Orone-mini-S8D-v0r001	
Inspired by Maple mini by okie and Mini48 by siy at https://github.com/siy/openstm32hw	Copyright 2013 G Bulmer
	16/04/2013 20:44
Significantly changed to improve it, see Notes, and make DIY-able.	Sheet: 1/1

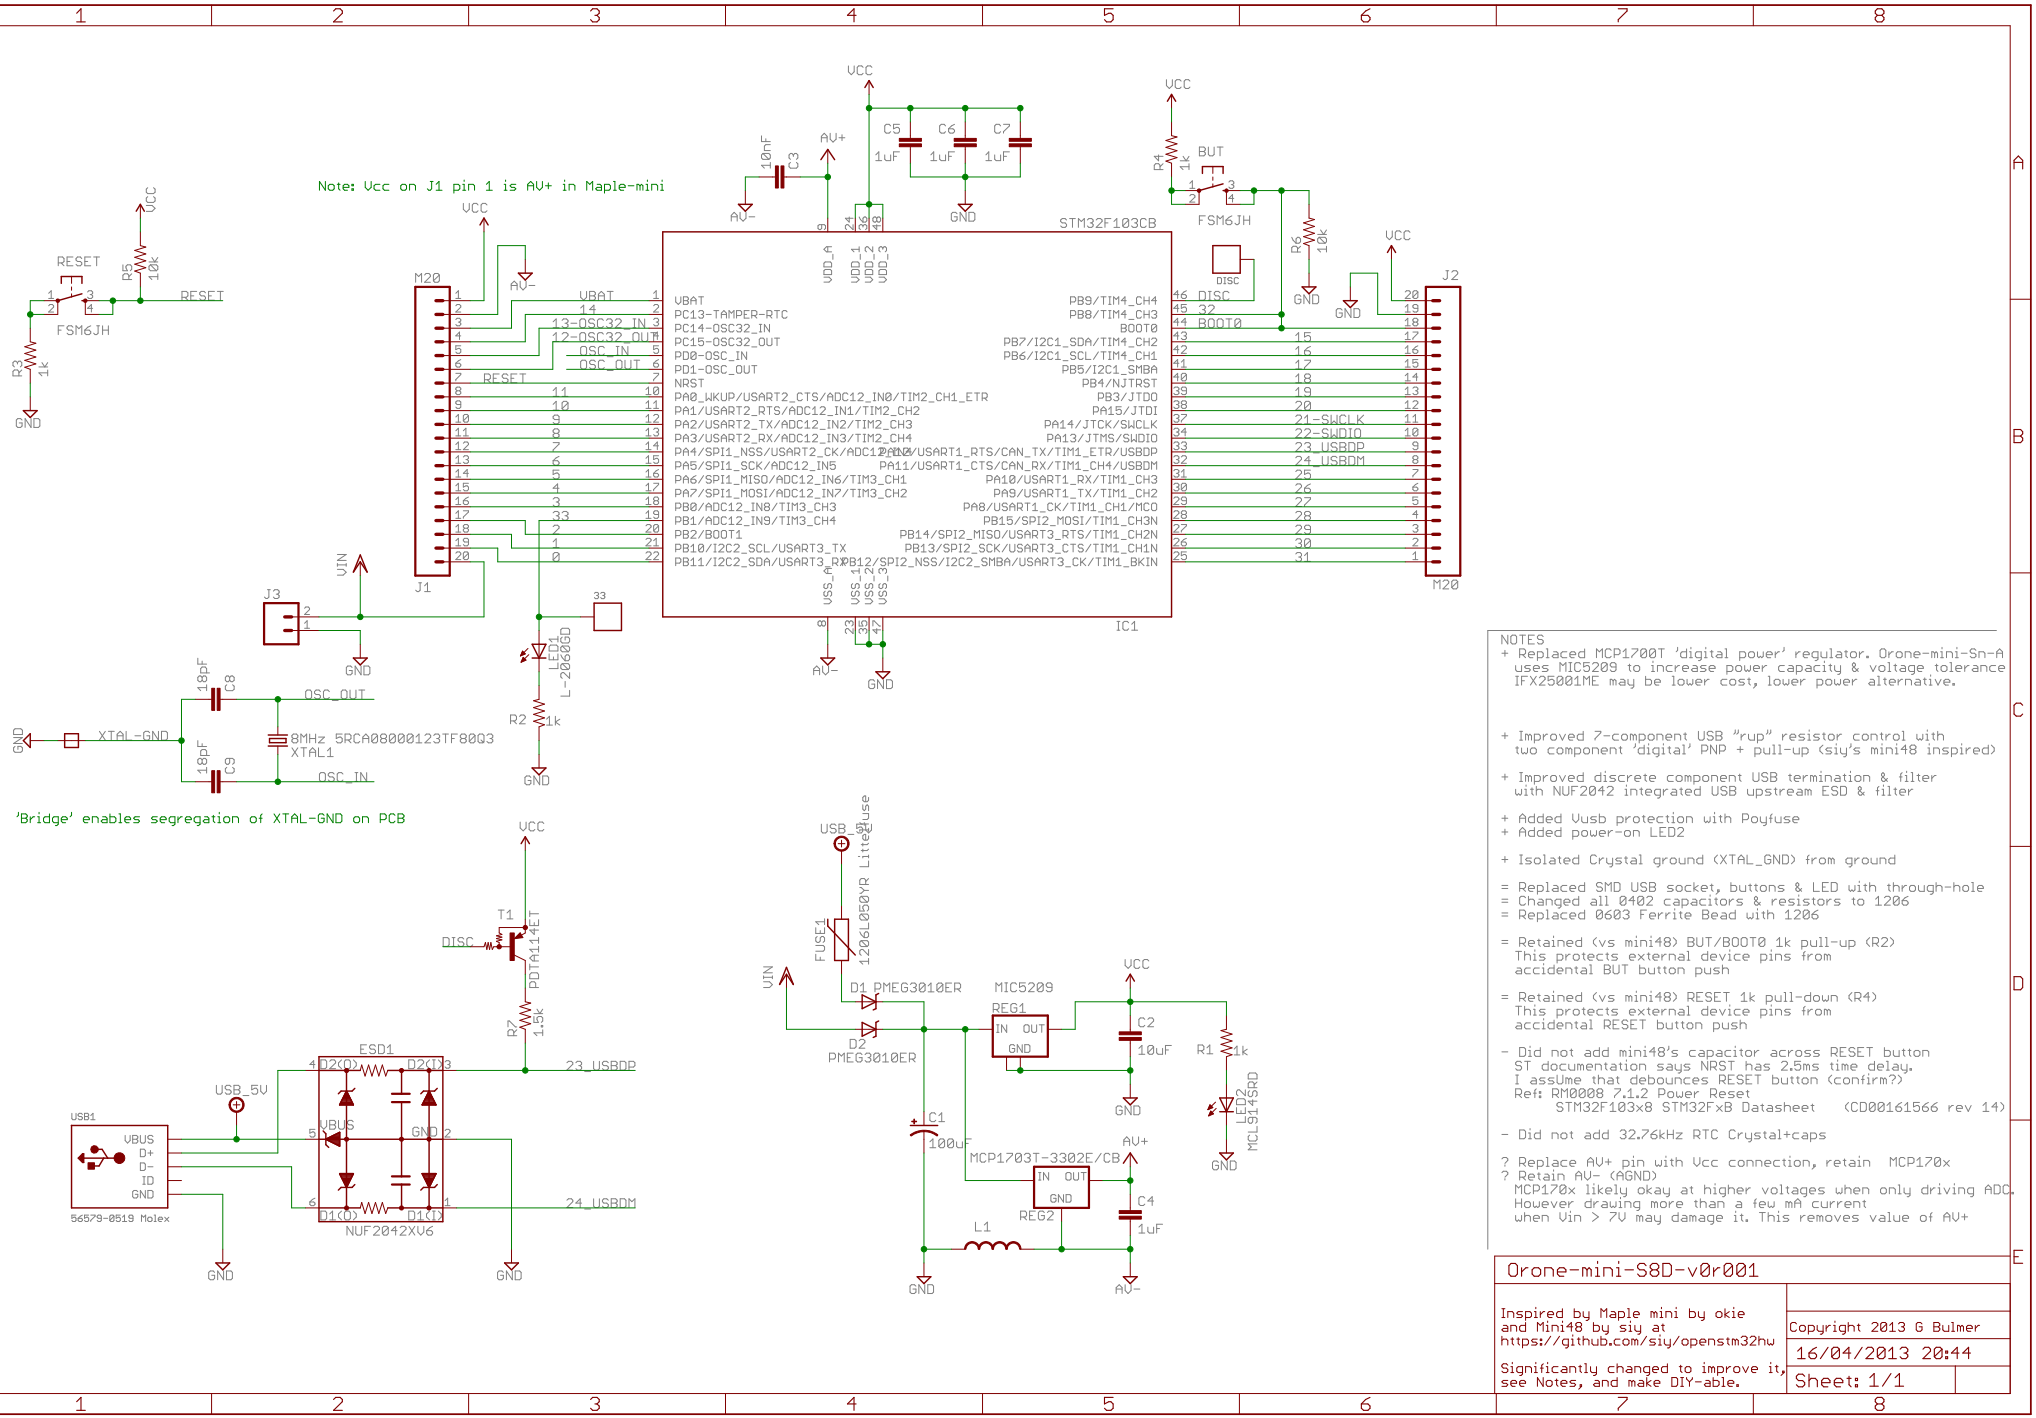
+ Replaced MCP1700T 'digital power' regulator. Orone-mini-Sn-A uses MIC5209 to increase power capacity & voltage tolerance IFX25001ME may be lower cost, lower power alternative.

+ Improved 7-component USB "rup" resistor control with two component 'digital' PNP + pull-up (siy's mini48 inspired)

+ Improved discrete component USB termination & filter with NUF2042 integrated USB upstream ESD & filter

+ Added Vusb protection with Poyfuse
+ Added power-on LED2

+ Isolated Crystal ground (XTAL_GND) from ground

= Replaced SMD USB socket, buttons & LED with through-hole
= Changed all 0402 capacitors & resistors to 1206
= Replaced 0603 Ferrite Bead with 1206

= Retained (vs mini48) BUT/BOOT0 1k pull-up (R2)
This protects external device pins from accidental BUT button push

= Retained (vs mini48) RESET 1k pull-down (R4)
This protects external device pins from accidental RESET button push

- Did not add mini48's capacitor across RESET button
ST documentation says NRST has 2.5ms time delay.
I assUme that debounces RESET button (confirm?)
Ref: RM0008 7.1.2 Power Reset
STM32F103x8 STM32FxB Datasheet (CD00161566 rev 14)

- Did not add 32.76kHz RTC Crystal+caps

? Replace AV+ pin with Vcc connection, retain MCP170x
? Retain AV- (AGND)
MCP170x likely okay at higher voltages when only driving ADC. However drawing more than a few mA current when Vin > 7V may damage it. This removes value of AV+
